Historic Preservation Board Agenda August 4, 2016 - 4:00 PM

Certificate of Appropriateness
HB 16-37 (New Construction)
301 River St.

STAFF REPORT

DATE: July 29, 2016
TO: Historic Preservation Board members
FROM: Thad Crowe, AICP
Planning Director

Figure 5: east elevation (facing river)

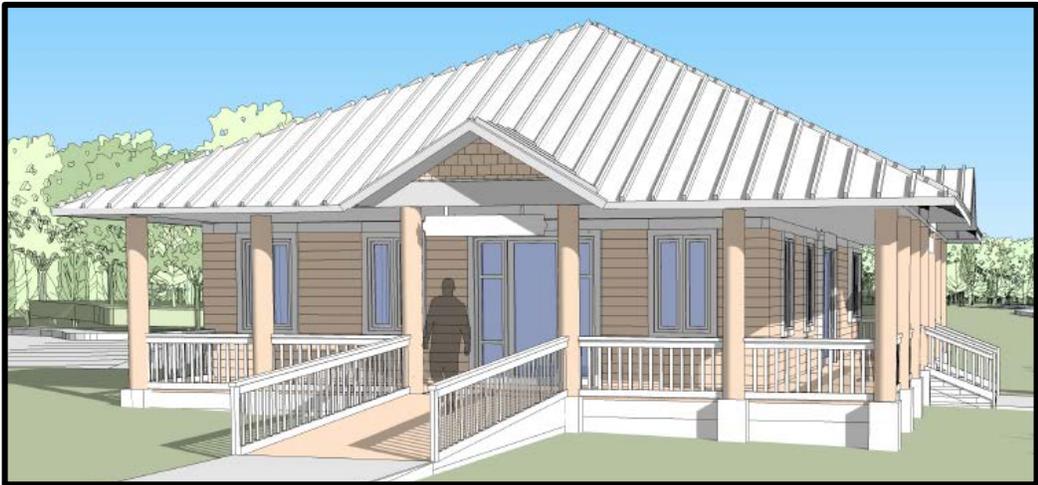
Staff would note that elevations such as these tend to present more of a stark appearance without foundation plantings, which in this case will be utilized to soften and compliment the building. The river and boat ramp facades (east and south) have an upgraded appearance due to the porch and window/door arrangement. The other facades have a more utilitarian appearance, which is appropriate as they are secondary and not main facades - it is important to identify the main facades and entrances with this enhanced architecture. However the lack of a second window on the north elevation gives that fairly visible and prominent façade an off-balance look and presents too much blank wall. The Applicant indicated that no window is provided in this location since it is a bathroom. However as was the case with the recently approved Housing Authority home on Laurel St. the Board required the addition of windows to provide for more symmetry and also compatibility with vicinity structures. Staff recommends that a window similar to the other North façade window be provided – bathroom windows also help for ventilation and lighting – and window blinds or opaque glass be

Staff would note that the windows, while resembling casement windows, are not the one-over-one windows typically utilized in simple frame vernacular buildings. Casement windows are more associated with the bungalow architectural style, or with sunrooms in vernacular homes. However staff does not object to the use of these windows, as they help to accomplish the goal of setting the building apart from historic structures while retaining the verticality common to historic windows.

Staff recommends approval of COA HB 16-37 as presented with the following design revisions to improve building appearance and compliance with COA criteria:

- add matching window to north façade, to provide for symmetry and soften the appearance of the blank wall effect;
- as an alternative, utilize a realistic-looking faux window for added north façade window, or utilize opaque – not frosted – glass;
- if opaque glass is utilized, soften appearance with strategic landscaping;
- add window to west façade to be placed between planned windows and door;
- provide foundation plantings including shrubs/hedge along all facades, and with interspersed taller plantings along the north and west facades;
- consider use of fish-scale shingles in east and south façade pediments to provide nautical reference; and
- include inset glass on west façade door.
